Technical Memorandum

Ref: 16-002518-WTM02-Rev3

Subject: Covella - Water Precinct Network Plan Amendments

Covella - Water Precinct Network Plan Amendments

Attachment 1: Revised Internal Water Service Strategy Drawing No. 15-003700-SK2900.

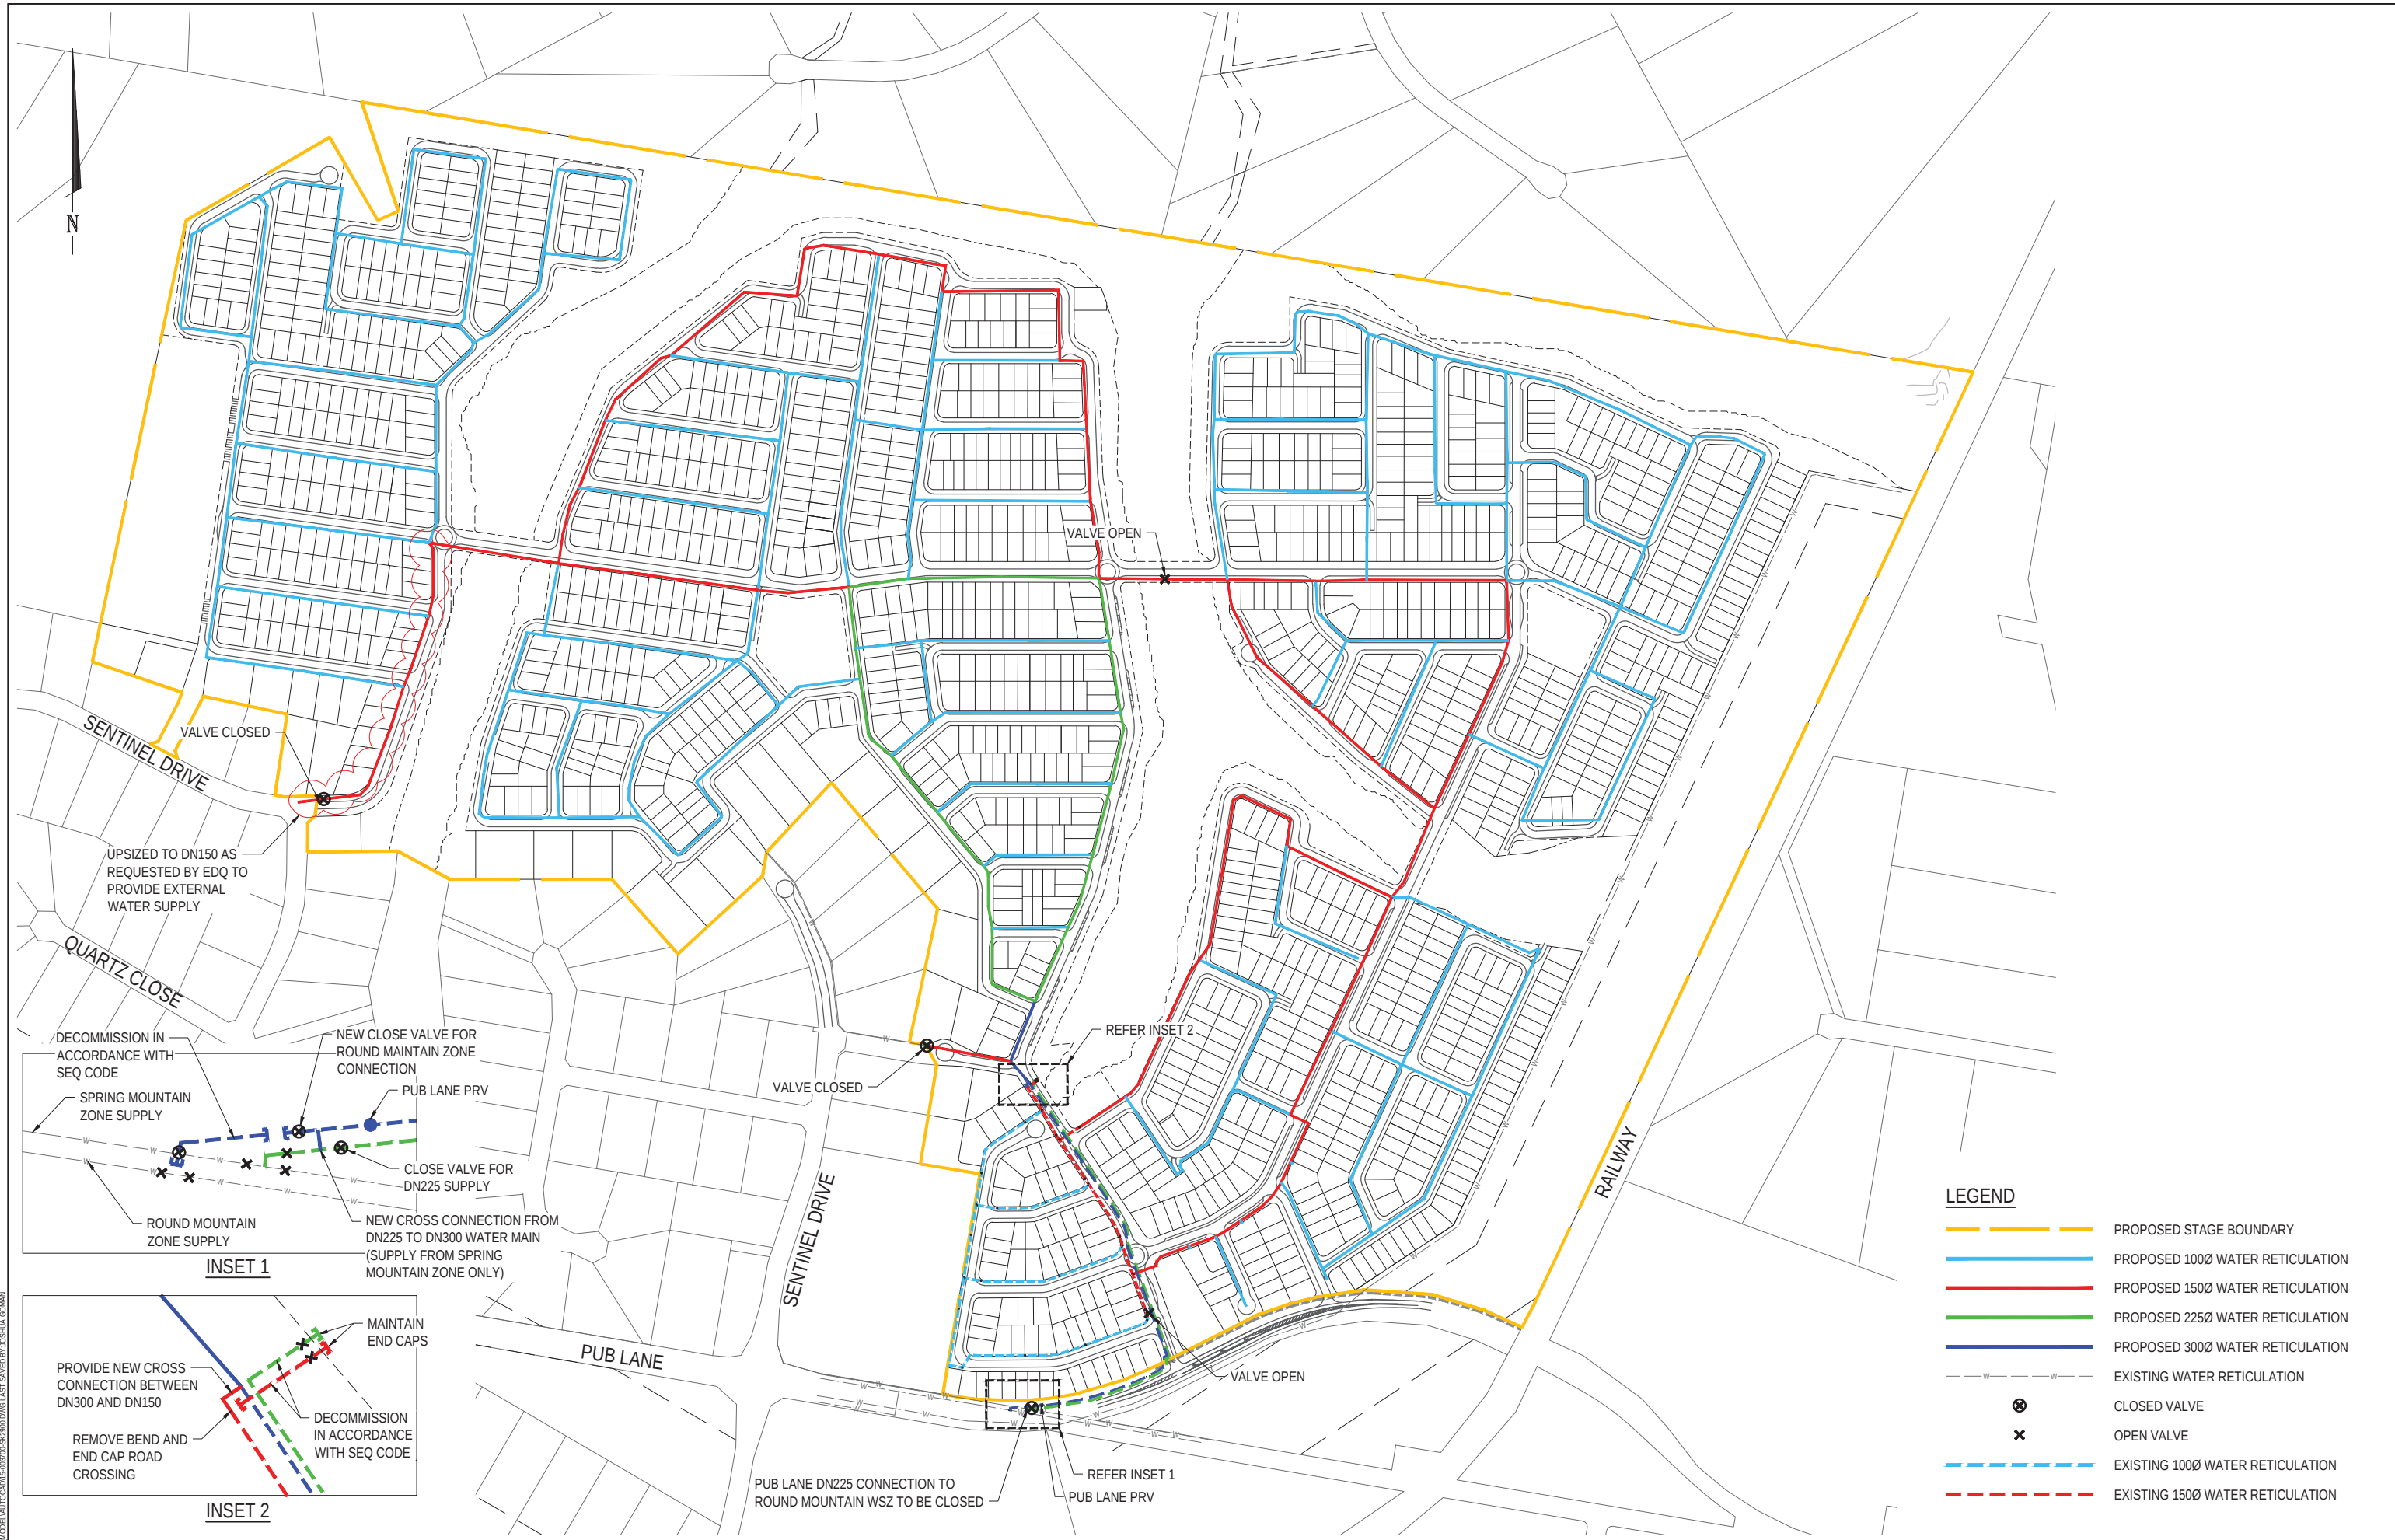
The revised network configuration is illustrated on Drawing No. 15-003700-SK2900 enclosed within Attachment 1. To service the development via the Spring Mountain WSZ only, existing boundary valves will be opened, and cross connections made between the two constructed supply mains. It should be noted that the existing Pub Lane Pressure Reducing Valve (PRV) will remain operational with cross connections between the two supply mains made after the PRV.

At the time of reporting, the current development demand is 979.1 EP which is greater than the 543.2 EP previously adopted for the interim development phase. To provide additional water supply capacity for future external development, EDQ have requested that a length of proposed DN100 water main be upsized to DN150 as shown on Drawing No. 15-003700-SK2900 enclosed within Attachment 1. Other than the changes proposed to the supply zone and upsized length of pipe, there have been no significant changes to the development layout and associated demands. Subsequently there has been little change to the updated internal network pressures outlined in Table 1.
